P23-15 Tru-Fit Addition

Property Owner: Reagan Land Company LLC
Applicant: Bob Workman
Location: 460 Lake Road
Zoning: I-1 (Industrial)
Request: Site Plan approval for a building addition and parking expansion

Staff recommends **approval** of application P23-15 as submitted.

SITE PLAN

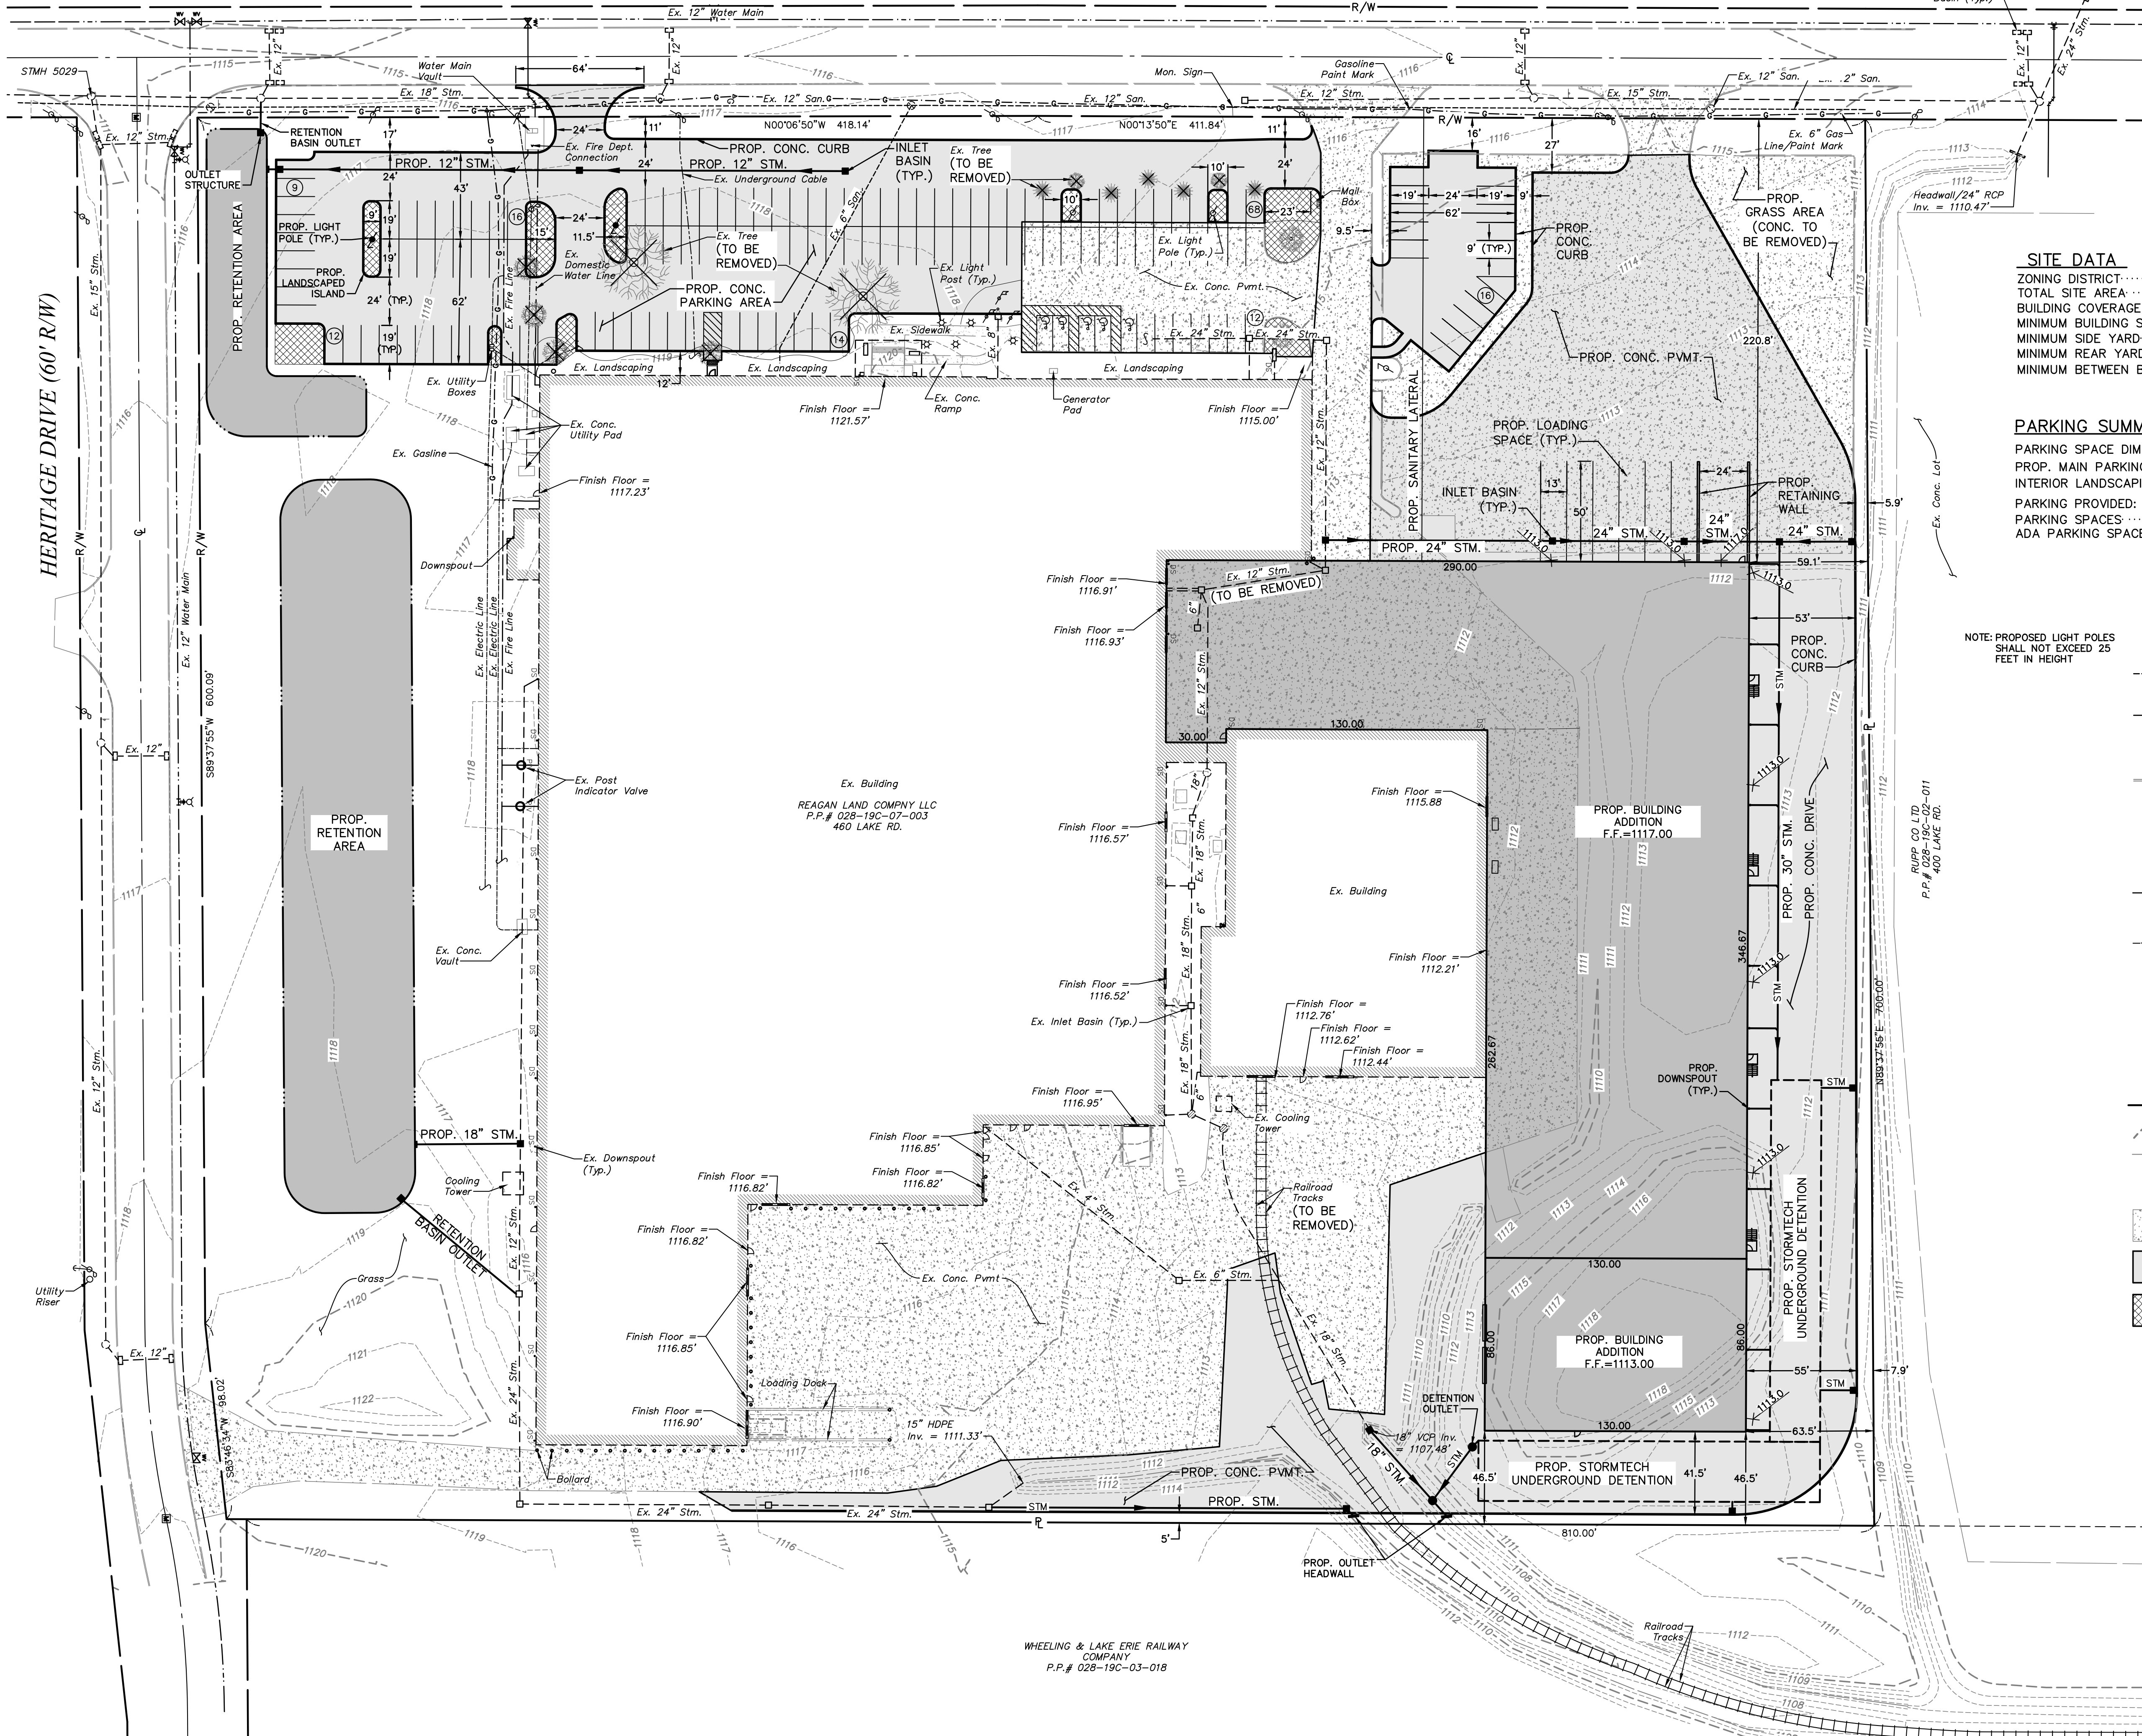
Access and Circulation – The site has currently has two access points off Lake Road and one access point off of Heritage Drive. Proposed plans add one additional access point off Lake Road to service the expanded passenger vehicle parking area. The access drive meets minimum and maximum width requirements.

The current site includes 127 parking spaces. The proposed plan removes parking spaces in the northwest corner of the site and extends an existing parking area to the south along Lake Road. The proposed site includes a total of 147 parking spaces. Though the addition is significant, the proposed parking appears to be adequate.

Parking Dimensions – Ninety-degree parking spaces must be 9 ft. in width and 19 ft. in length with a 24 ft. wide drive aisle. The proposed site meets this standard.

Loading Zones – Seven loading zone spaces are incorporated on the west side of the addition, facing Lake Road, which are accessed by overhead doors. As noted, parking was removed in this are to accommodate the proposed loading zones

Parking Lot Landscaping – Landscape features or other visual barriers are required between parking and the right-of-way. Plans show landscaping between parking and the right-of-way.

Interior parking lot landscaping is provided at the required 5 sq. ft. per 100 sq. ft. of parking area.

A buffer is required between loading zones and public streets. Plans incorporate landscaping between the loading zoned and Lake Road, providing a buffer.

SITE PLAN

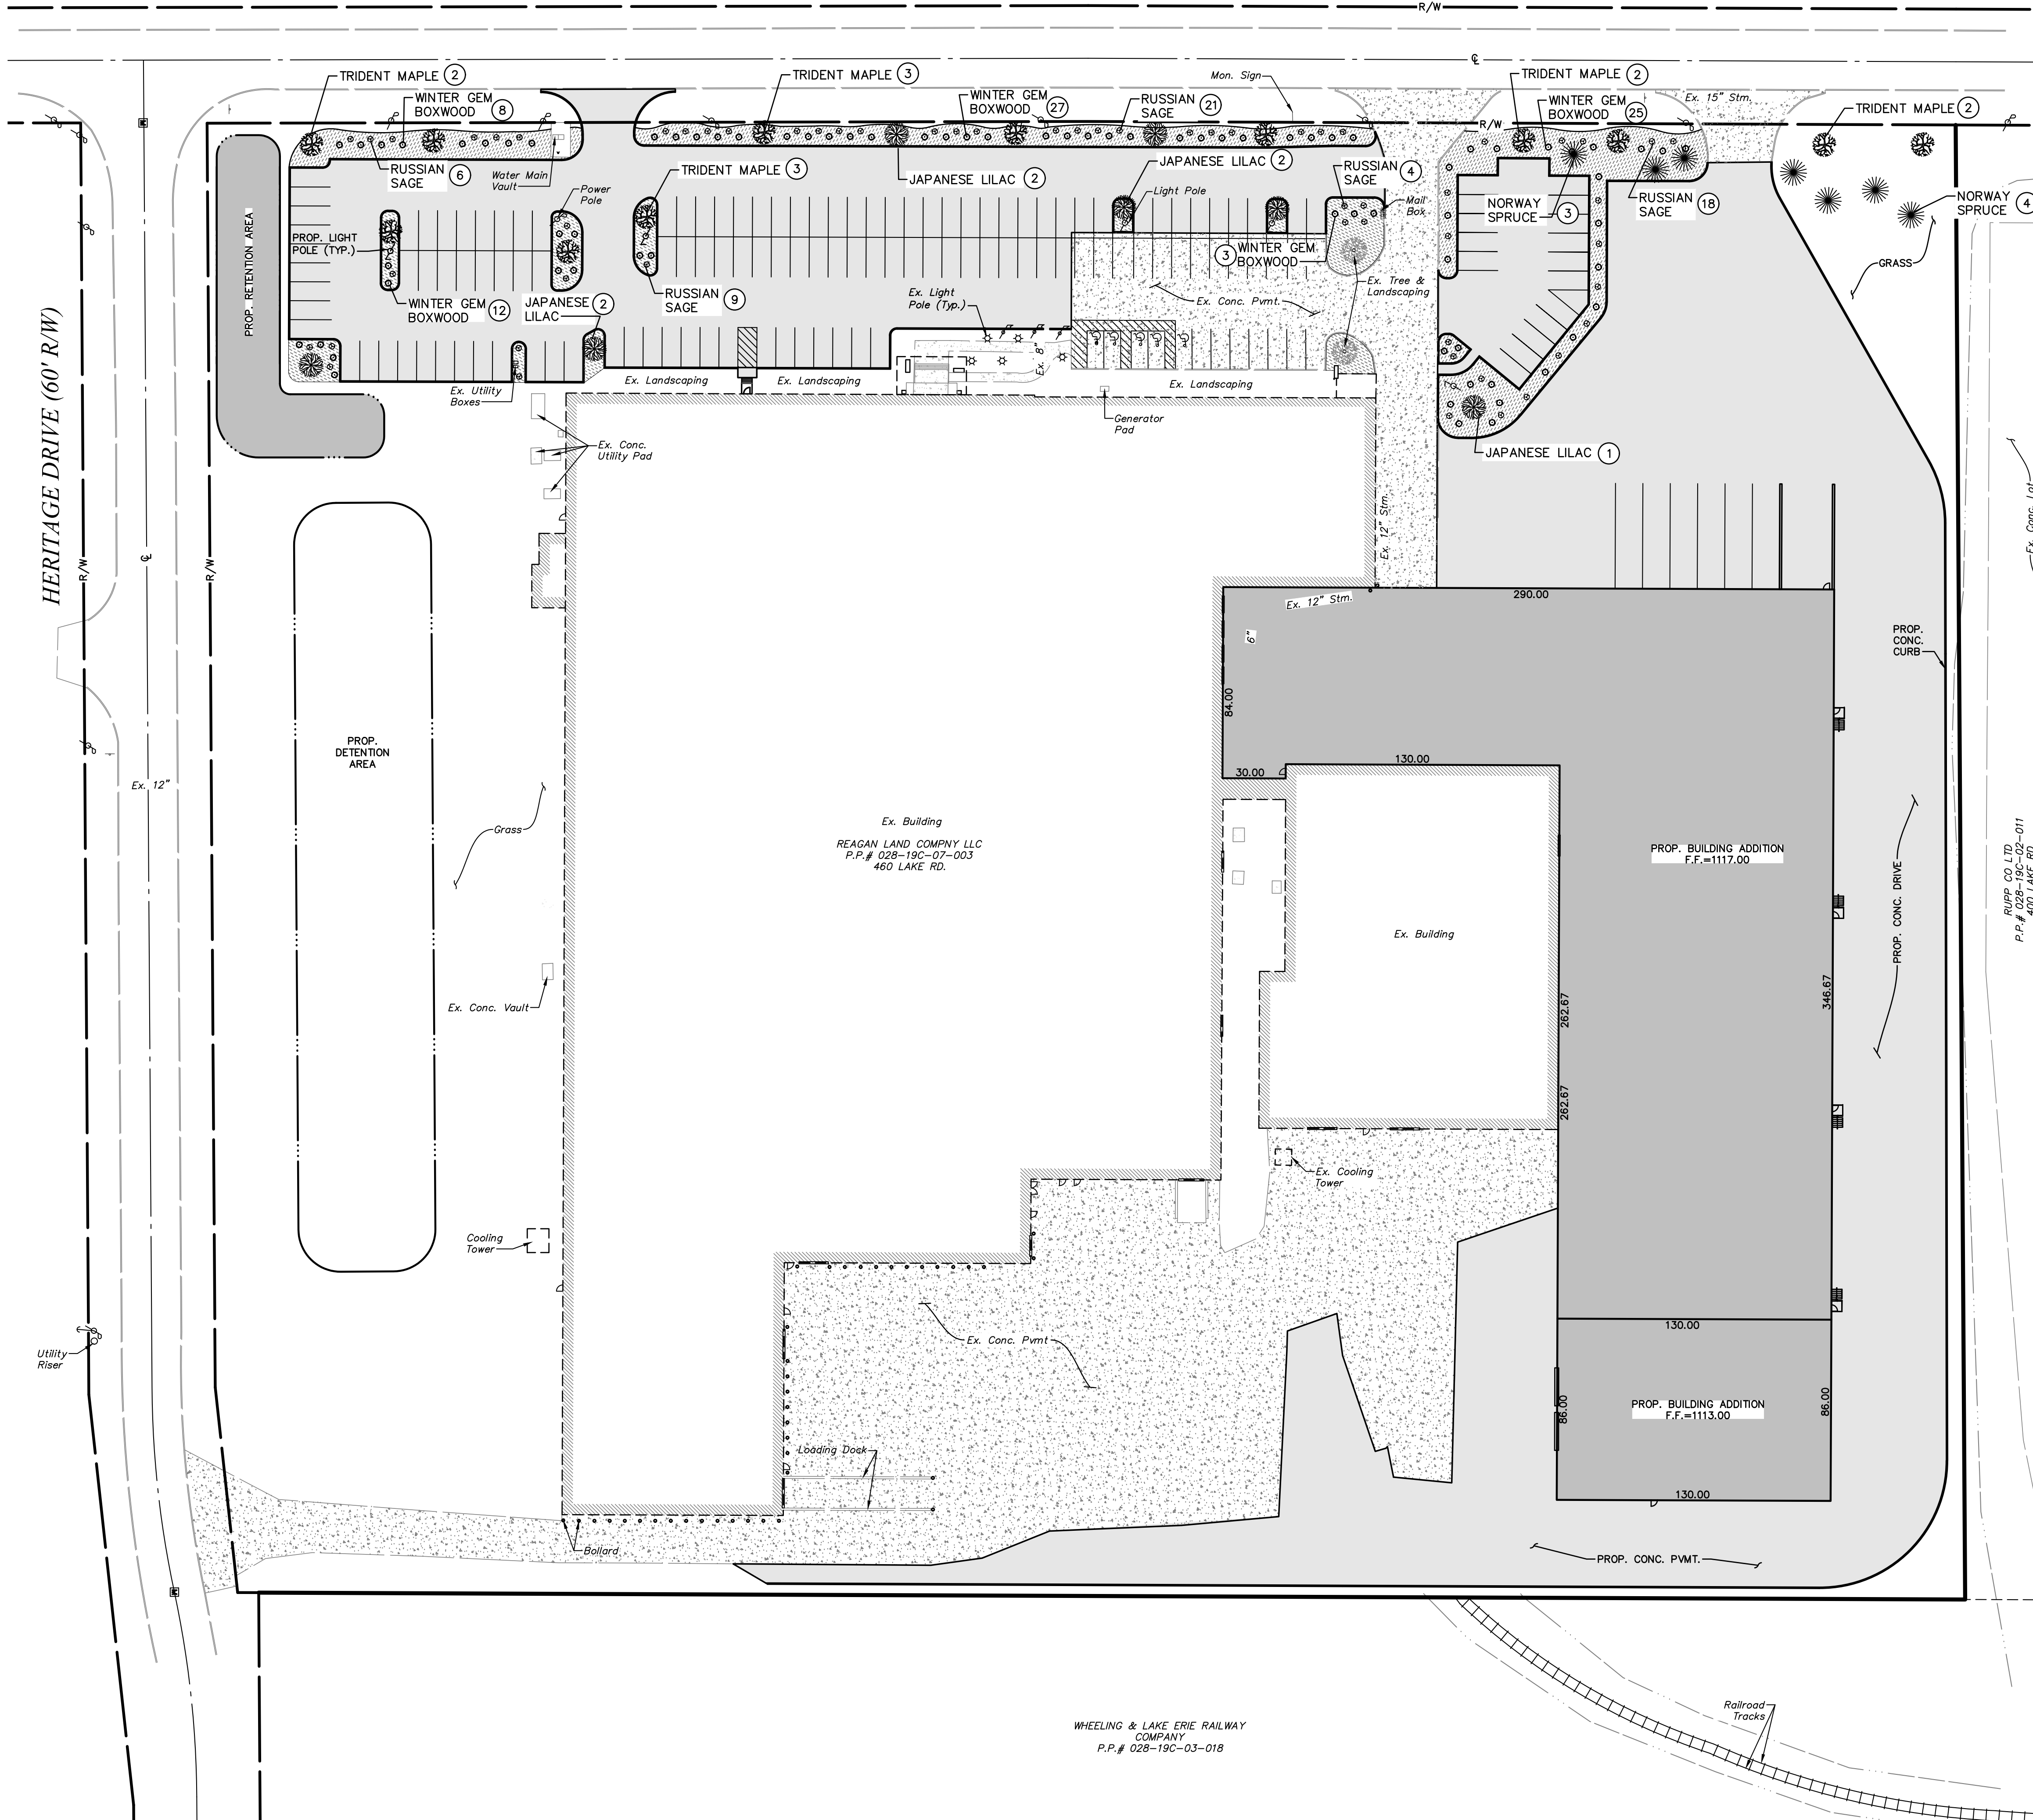
Buffering and Screening – Landscape features or other visual barriers are required between the site and residentially zoned properties. Residences on the west side of Lake Road are zoned I-1 (Industrial) in the city and LM (Light Manufacturing) in Lafayette Township. Though not required, a mix of plantings has been proposed along Lake Road to provide a light buffer.
